**TO: PARTIES INTERESTED IN EVALUATION REPORTS ON
CONTINUOUS ROD TIE-DOWN ASSEMBLIES**

**SUBJECT: Proposed Revisions to the Acceptance Criteria for Continuous Rod
Tie-down Assemblies, Subject AC391-0210-R1 (JS/BG)**

**PROPOSED REVISIONS TO THE ACCEPTANCE CRITERIA FOR
CONTINUOUS ROD TIE-DOWN ASSEMBLIES RUNS AND
CONTINUOUS ROD TIE-DOWN SYSTEMS RESISTING ROOF
WIND UPLIFT FORCES FOR LIGHT-FRAME WOOD
CONSTRUCTION**

AC391

Figure 2: CRTS Test Set-up

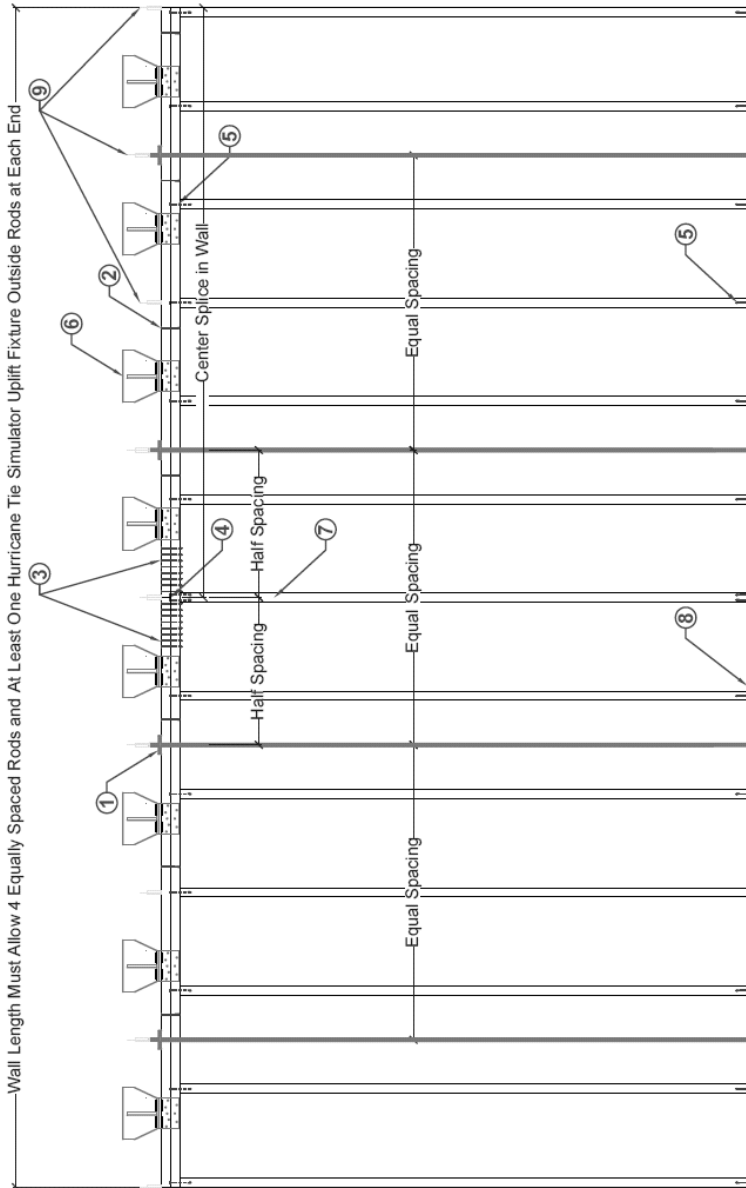
- c. Section 4.1.1 and Figure 2 of the proposed draft describe a new proposed test setup and assembly that would be required for cases where the applicant chooses to test the CRTS to derive allowable loads for the system. Staff seeks input on the availability of the necessary testing equipment, as described, among accredited testing laboratories.

294 **3.5.1.1 CRTS Test Setup:** The CRTS test setup shall be in accordance with
295 Section 4.0 and Figure 2.

305 shall be limited to the total load divided by the length of the wall corresponding to the
306 first instance of any span reaching a deflection of $L/180$, where L is the top plate span
307 length equal to the distance between CRTR. See Figure 2.
